REPORT TO CITY PLAN COMMISSION

Plan Commission Meeting Date: December 12, 2017

Item: Preliminary Plat – Creekside Estates

Preliminary Plat of

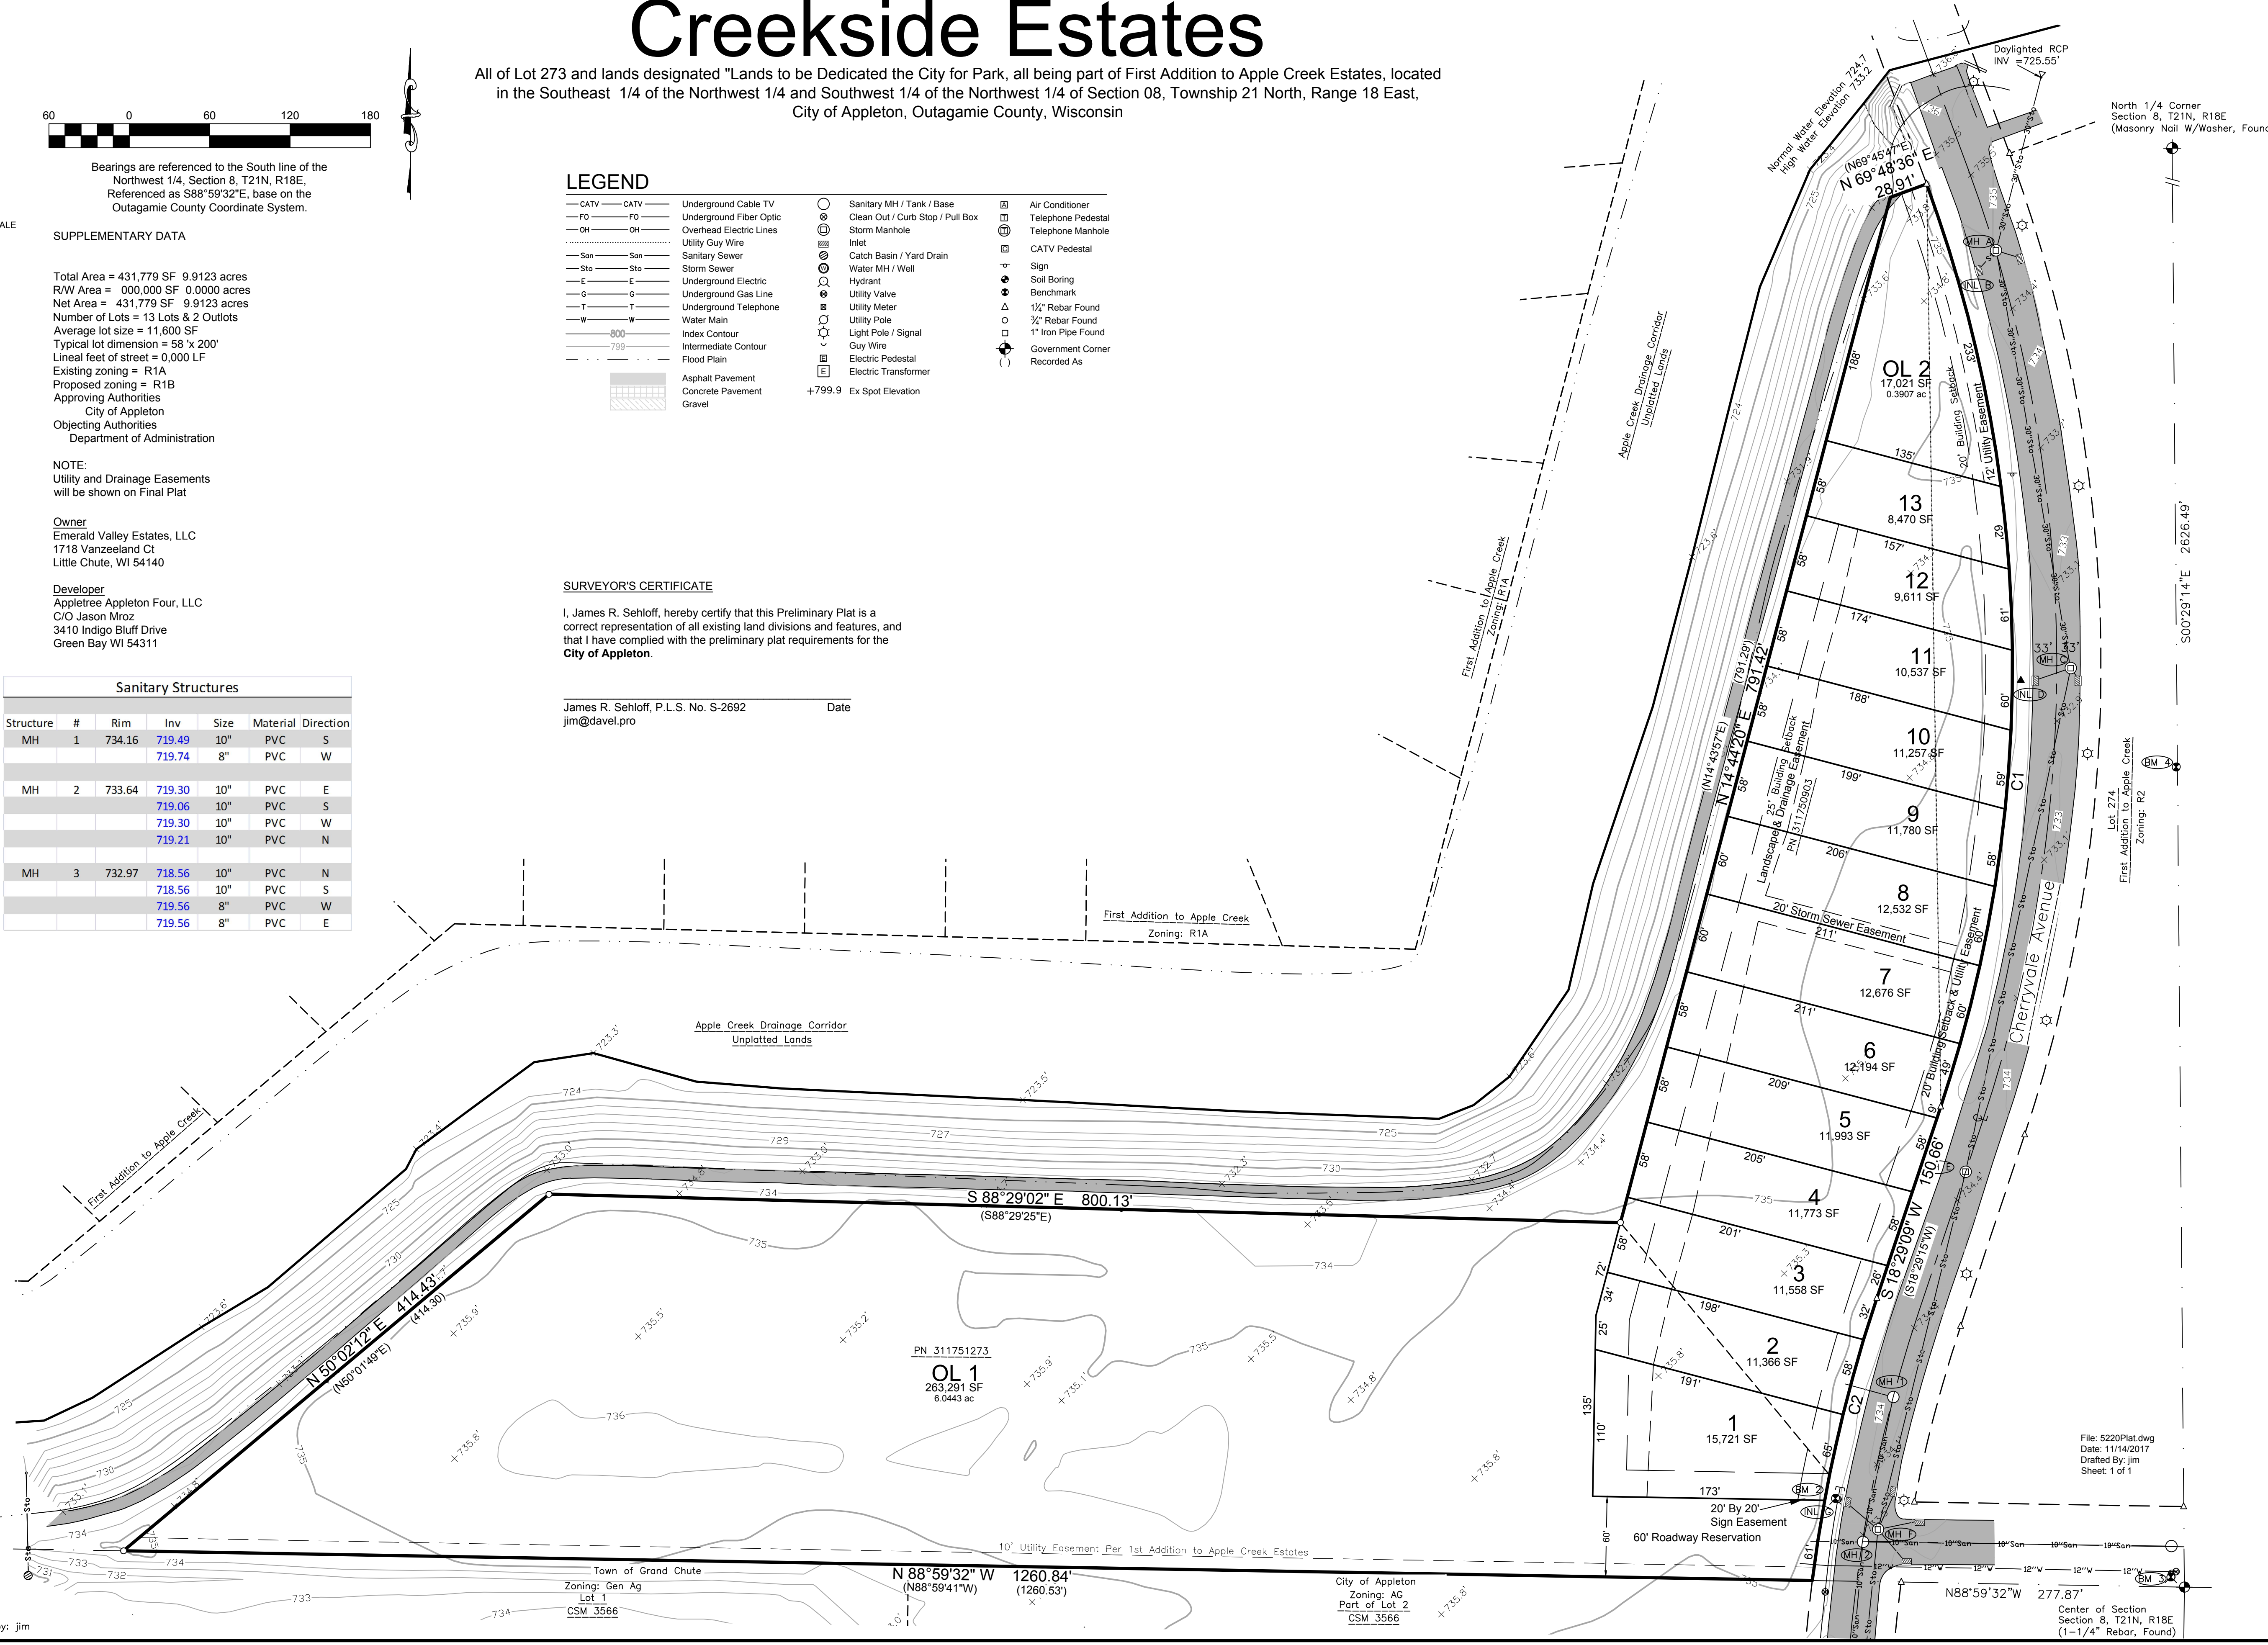
- Continued discussions are needed regarding the location of the public utilities.
- Existing asphalt pedestrian trail encroaches onto a small portion of Outlot 2.

2. All easements, including but not limited to, storm sewers, utility, and drainage shall be shown on the Final Plat to the satisfaction of the City Engineer. Easements as currently shown on the preliminary plat may require modifications prior to approval by the City Engineer.

4. Applicant shall continue discussions with the Department of Public Works regarding locations of all public utilities. Final approval is required by DPW prior to City signatures being affixed to the Final Plat.

7. Show all elevations on the Final Plat to City Datum (NAVD 29). Provide a note on the Final Plat that identifies the conversion factor used to convert from FIS elevations (NGVD88) to City Datum.

8. A small portion of an existing city-owned asphalt pedestrian trail is located on Outlot 2. Applicant shall continue discussions with Staff to either deed the land to the City or provide an easement to encompass the trail.

10. A note shall be placed on the final plat noting ownership, use and maintenance of all outlots.

11. Park fees of \$3,900 shall be paid to the City of Appleton Finance Department prior to the City signatures being affixed to the Final Plat, unless otherwise stated in the Development Agreement.
12. Show 100-year floodplain limits and elevations.
13. The Preliminary Plat and Rezoning #8-17 being acted on at the same Common Council meeting.
